RFID Module

Changes on v10:

Released under the Creative Commons Attribution Share-Alike 4.0 License https://creativecommons.org/licenses/by-sa/4.0/		
TITLE: \${PROJECTNAME}		
Design by: N. Seidle	REV: v10	
Date: \${CURRENT_DATE}	Sheet: \${#}/\${##}	Rev: 1/1

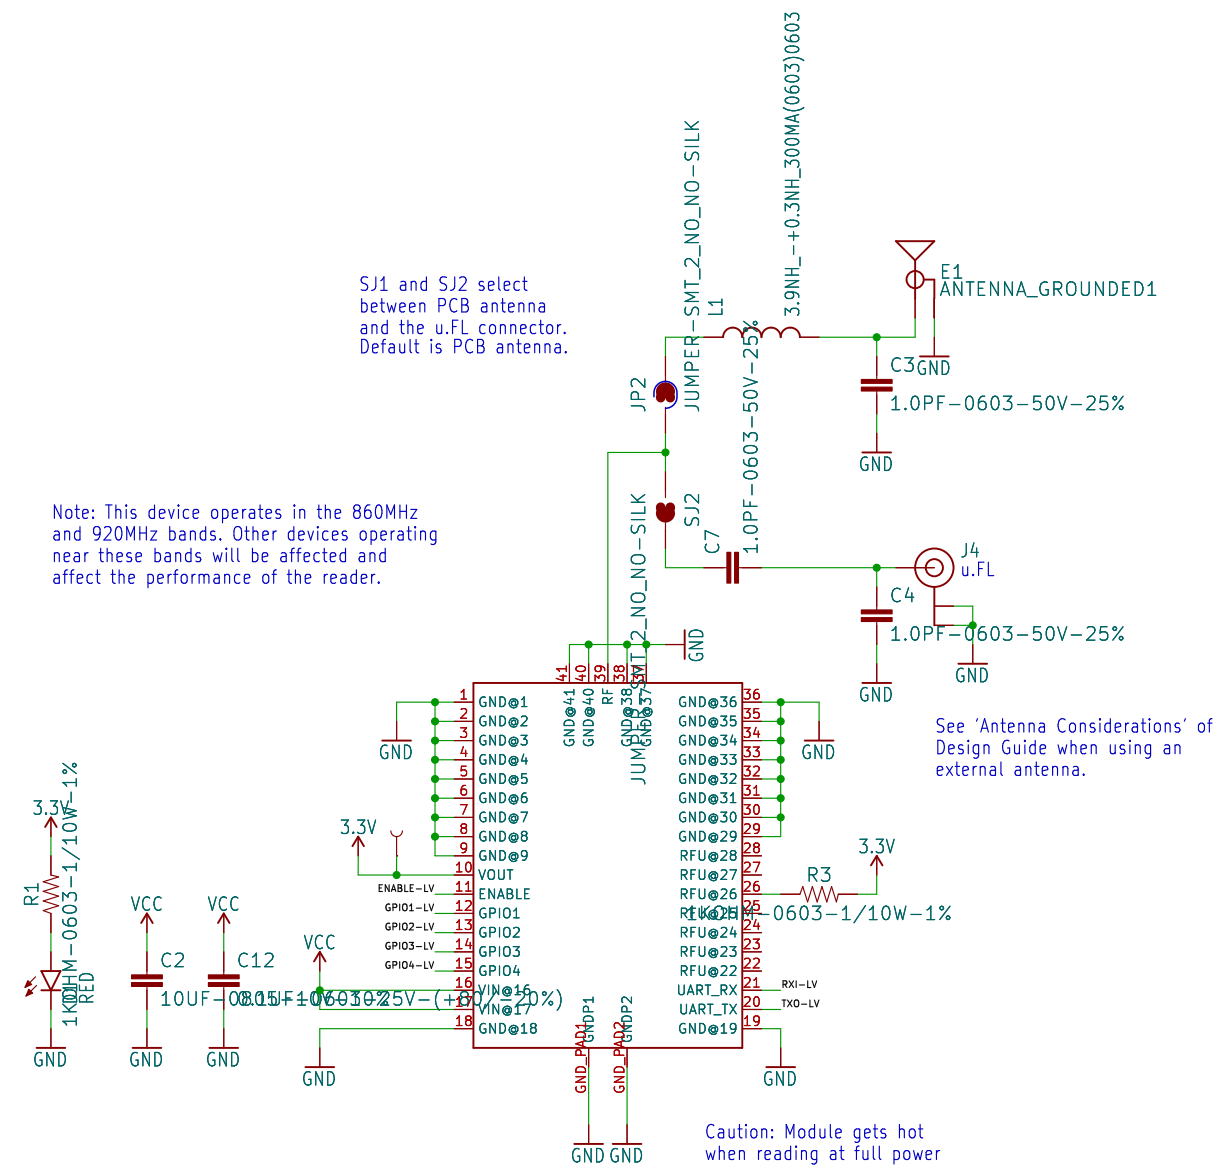
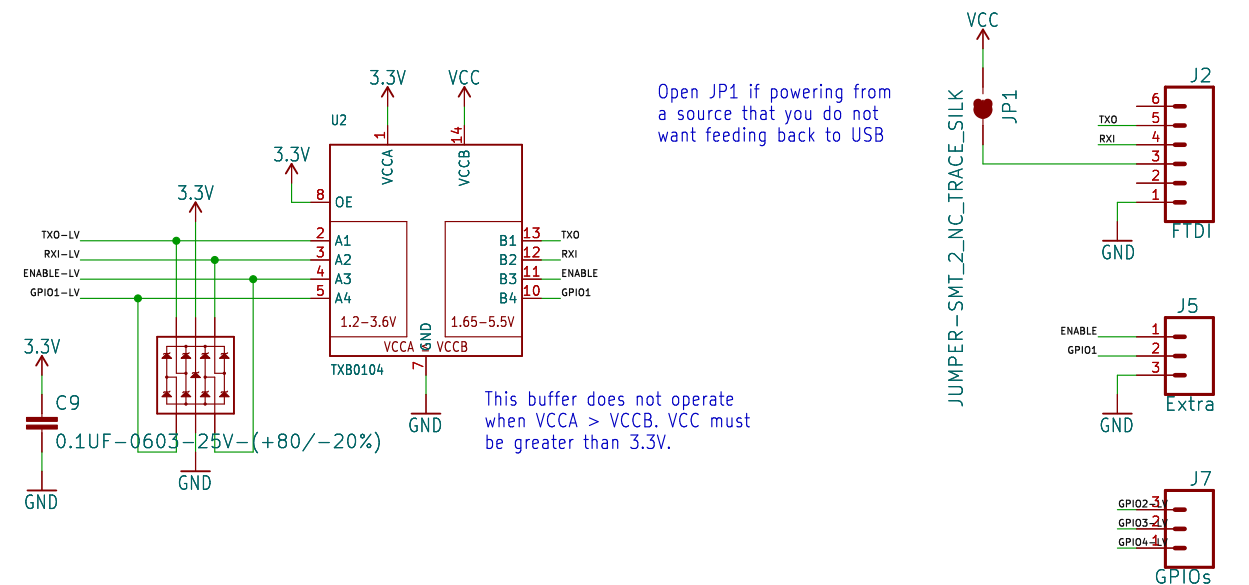
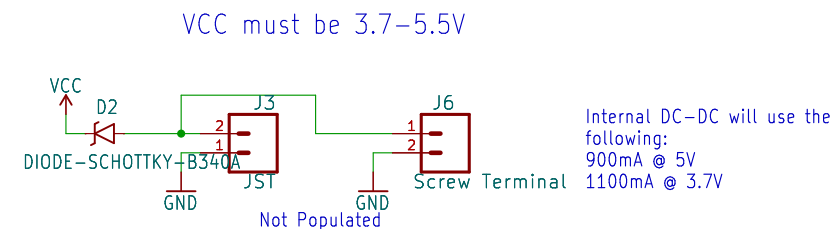
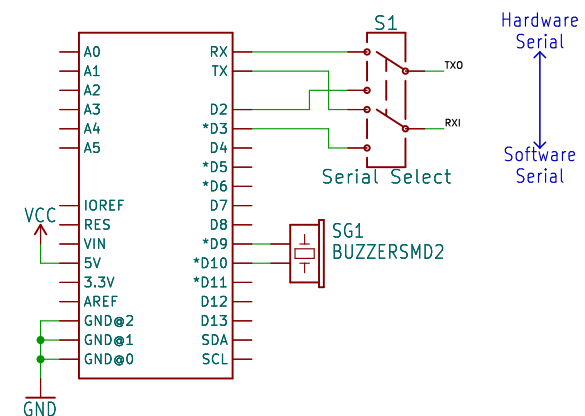
- Decreased size of RF pad to avoid GND pad on module
- Finalized trace antenna design and matching network
- Added thermals to user solderable GND connections
- Opened up heatsink area on bottom of PCB
